Project	IEEE 802.16 Broadband Wireless Access Working Group < http://ieee802.org/16 >
Title	Proposed text and ASN.1 code to support MOB_NBR-ADV
Date Submitted	2007-01-11
Source(s)	Joey Chou Intel Corporation [mailto:joey.chou@intel.com]
Re:	
Abstract	This contribution proposes the text and ASN.1 code in wmanIf2mMib to support MOB_NBR-ADV message.
Purpose	Adoption
Notice	This document has been prepared to assist IEEE 802.16. It is offered as a basis for discussion and is not binding on the contributing individual(s) or organization(s). The material in this document is subject to change in form and content after further study. The contributor(s) reserve(s) the right to add, amend or withdraw material contained herein.
Release	The contributor grants a free, irrevocable license to the IEEE to incorporate material contained in this contribution, and any modifications thereof, in the creation of an IEEE Standards publication; to copyright in the IEEE's name any IEEE Standards publication even though it may include portions of this contribution; and at the IEEE's sole discretion to permit others to reproduce in whole or in part the resulting IEEE Standards publication. The contributor als

Figure 19—wmanIf2mBsCm structure

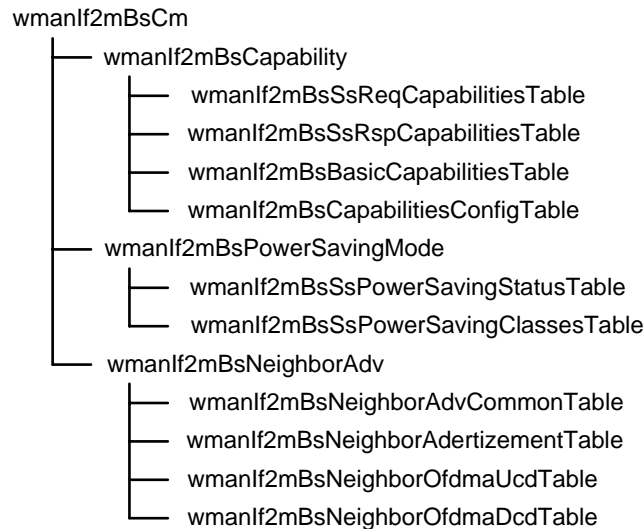
9 [\[Change Figure 19 as the following:\]](#)
